Seattle Goodwill Industries Job Training & Education Center

MUP Design Review September 27, 2011 DPD Project #3012125

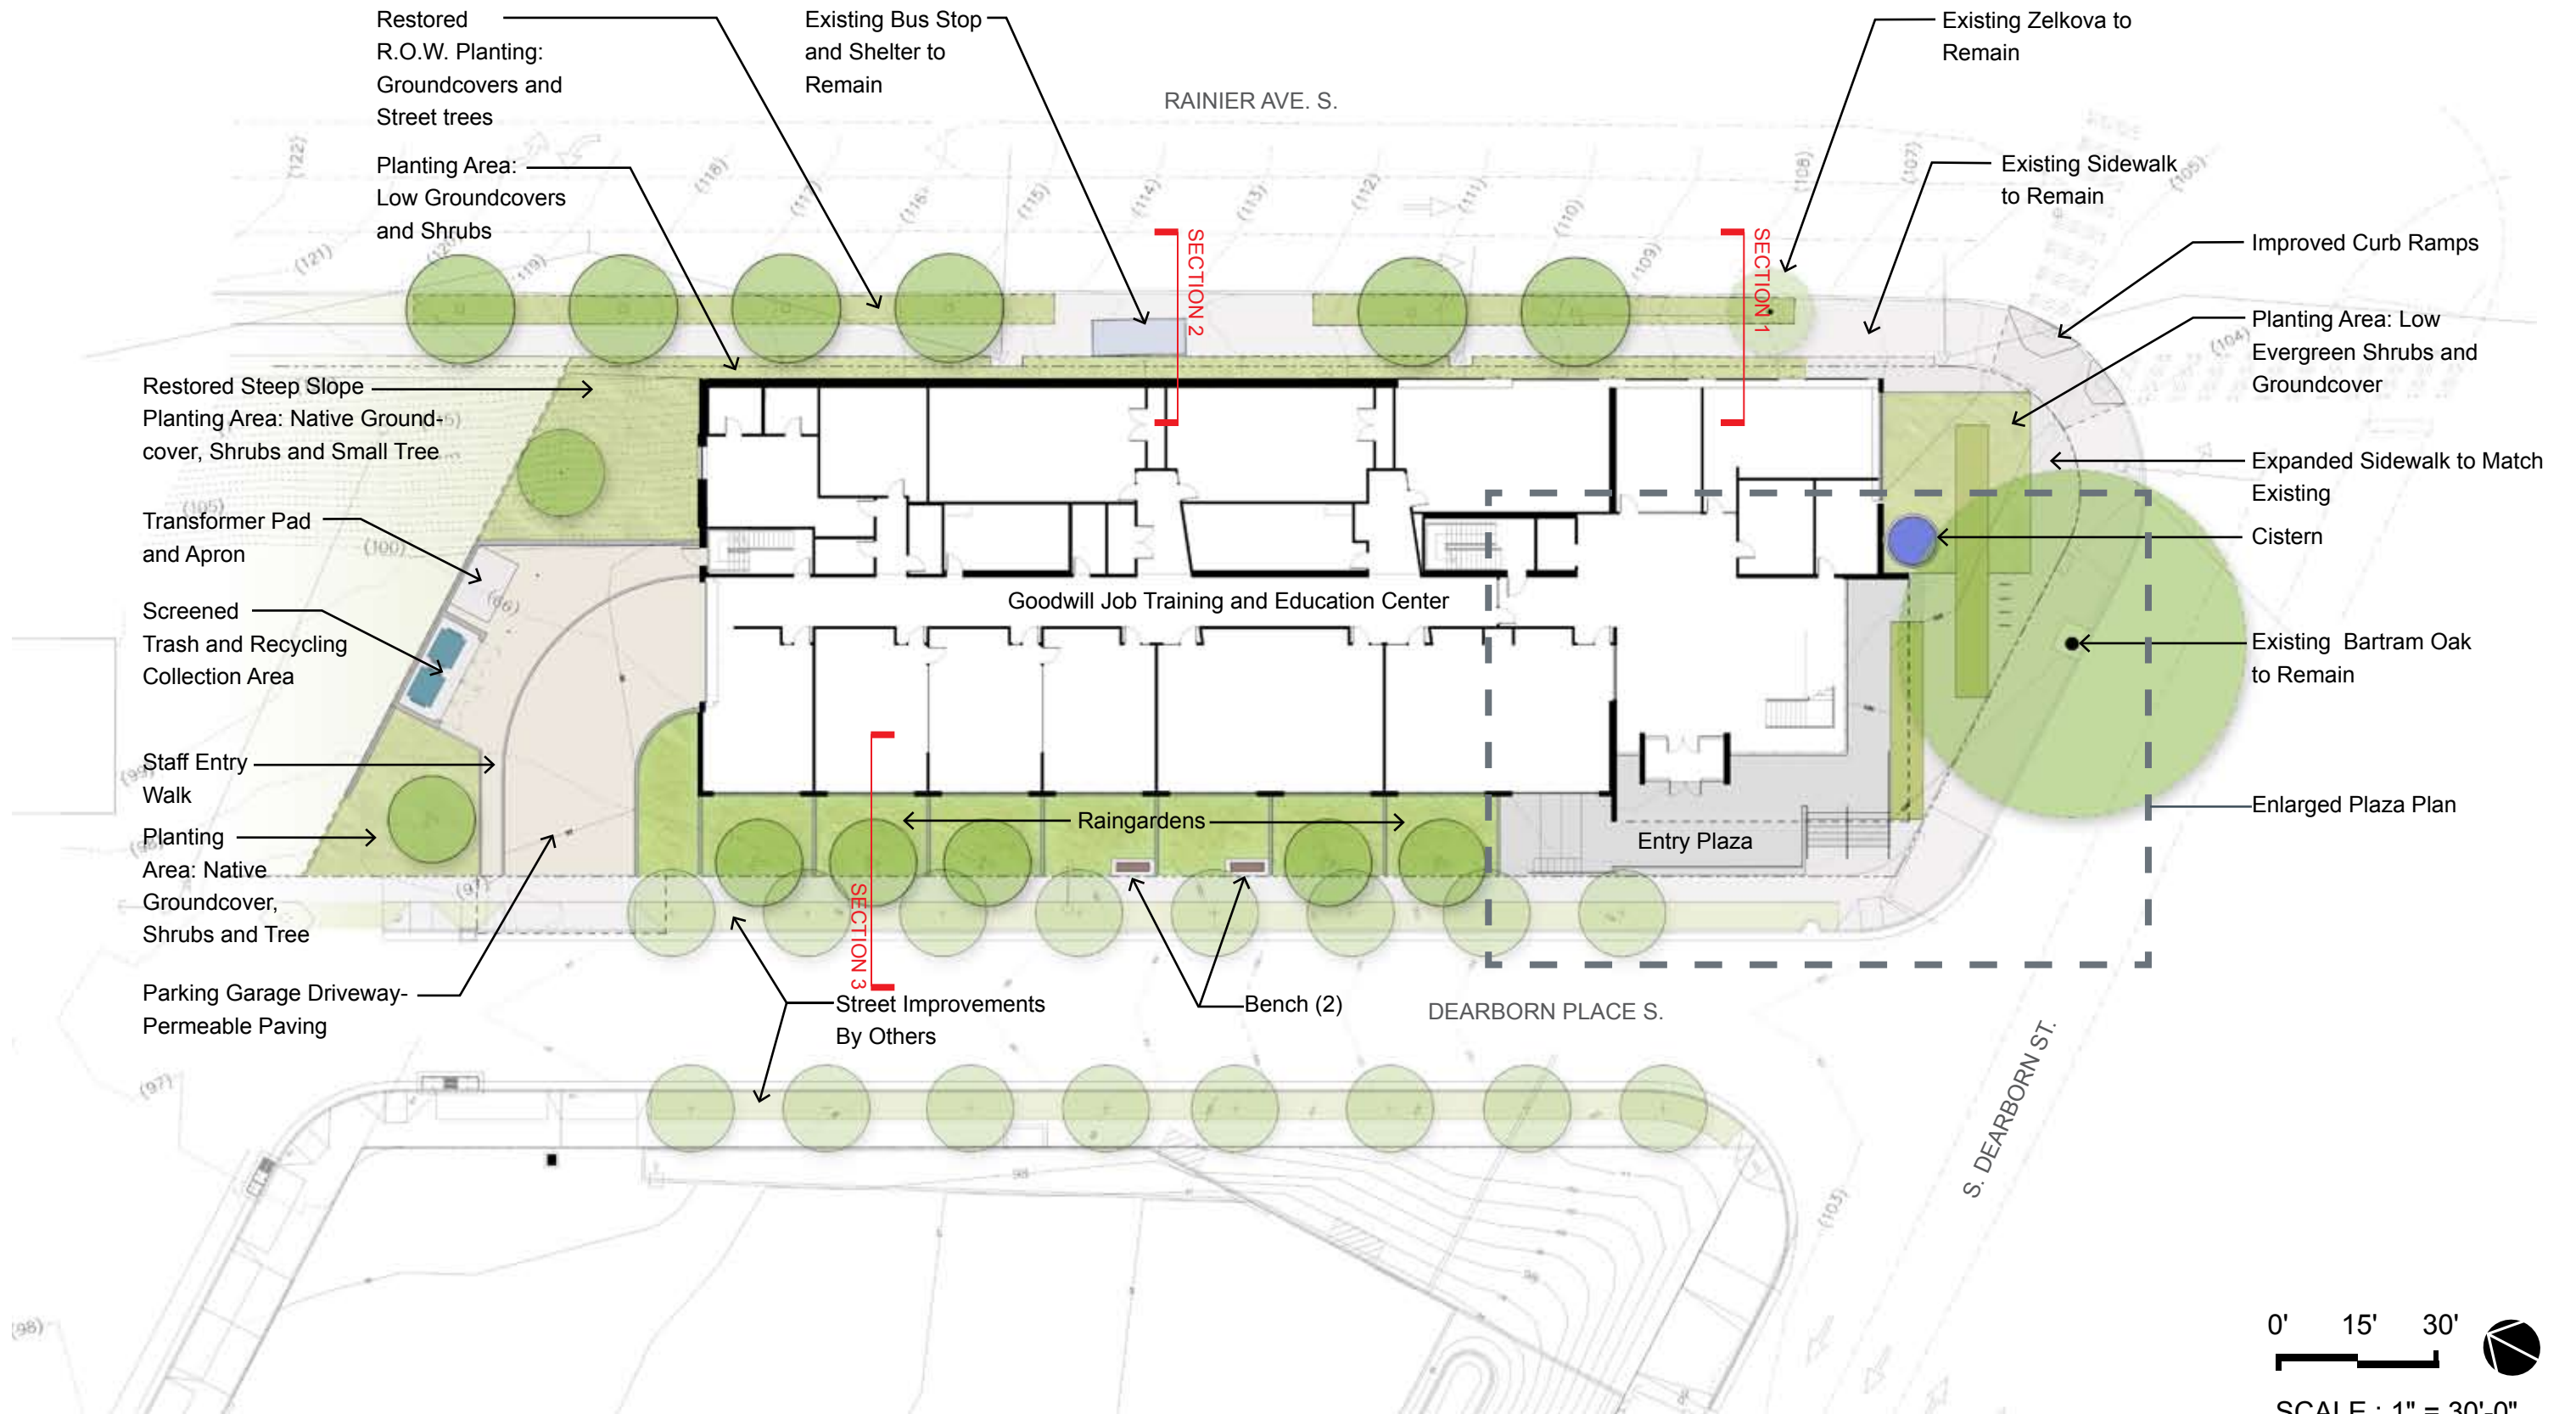
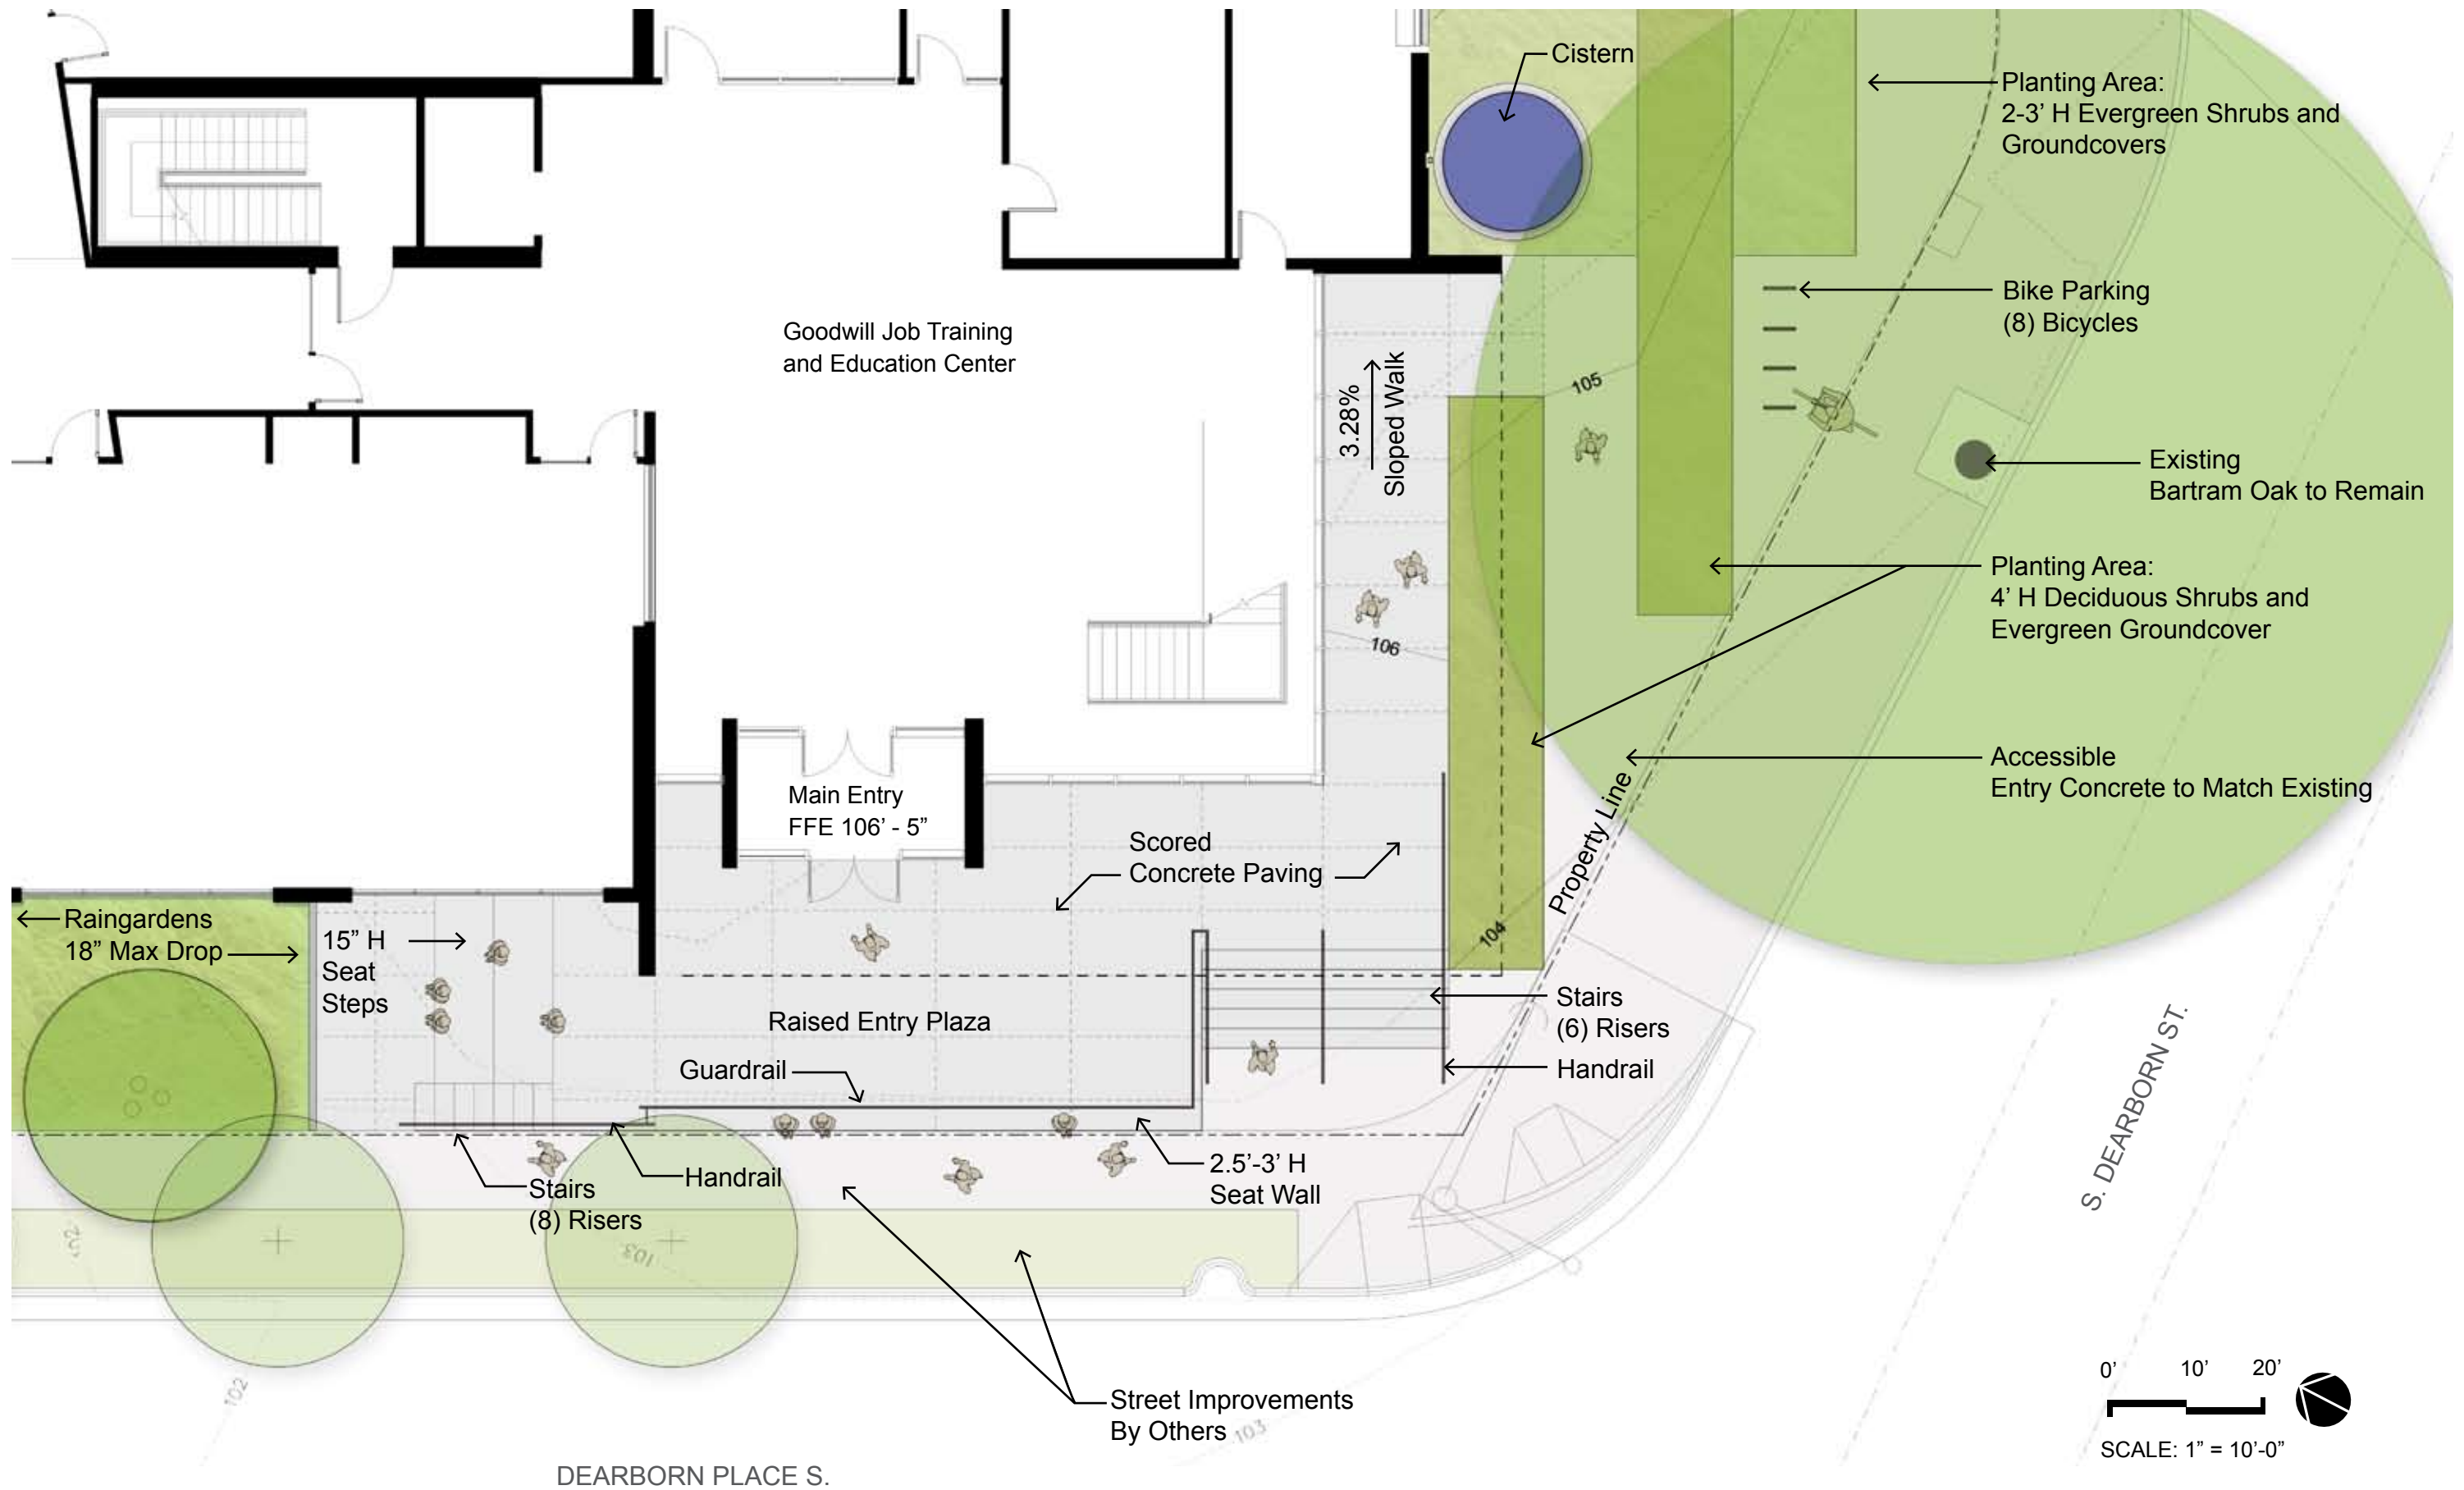
E-2 Landscaping to Enhance the Building and/or Site	#18 - At the Early Design Guidance Meeting, the Board stated that the landscape proposed should be shown and it should be demonstrated how the landscape will relate to future development of the Goodwill properties. In general, the landscape is very important to the proposal and needs to be well developed at the recommendation meeting.	See Site Plan. The landscape plan for the entire Goodwill campus is not part of this phase of the development. However, the proposed design for this project does not preclude any future plans. By holding the building back from S. Dearborn Street, this project keeps views from Rainier Avenue and S. Dearborn open to the rest of the campus and any future developments. The addition of trees, planting areas, rain gardens and site seating along the east façade of the building improves the pedestrian experience along Dearborn Place S., which will be an important visual and physical connection to future development.

ENTRY - big blue lily turf, heavenly bamboo-Moon Bay, Isanti dogwood, blue-green moor grass, existing Bartram oak

NORTH SIDE - kinnikinnick, longleaf mahonia, beaked filbert, tall oregon grape, indian plum, red flowering currant, bald hip rose, cascara

RAINIER STREET SCAPE - Frontier elm, creeping mahonia, wintergreen, strawberry, sweet box, longleaf mahonia, existing tree

RAINGARDEN - palm sedge, dwarf red-twig dogwood, grooved rush, dwarf goat's beard, taper-tipped, lady fern, beach strawberry
